Planning Application Review of Application Ref: PLN/2025/0703

Campbell Park Northside, Phases 2-5, Central Milton Keynes

**Prepared by
DLP Planning Ltd
Bedford**

Figure 2: Detail from Figure 10 MK Alliance Plot – Blue indicating active frontages with weather protection

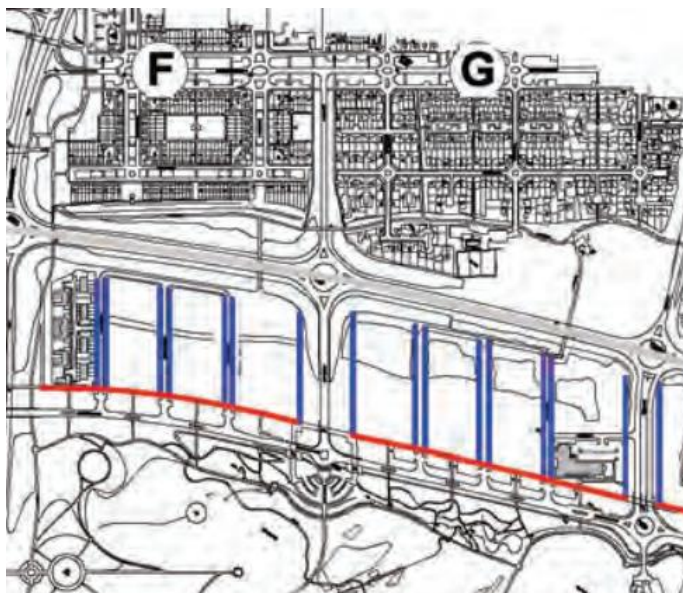
buildings will have ground floor community and commercial uses. Active frontages should be secured by condition in accordance with Figure 10 of the CMKAP ensuring that active frontages are provided on the north-south axis between blocklets.

- 8.32 The MK Alliance Plan Figure 10 sets out the expectations for active frontages with weather protection on the site. These run north-south in each block. However, the Illustrative Masterplan does not make provision for weather protection along these routes. Weather protection over pavements should be secured by condition.
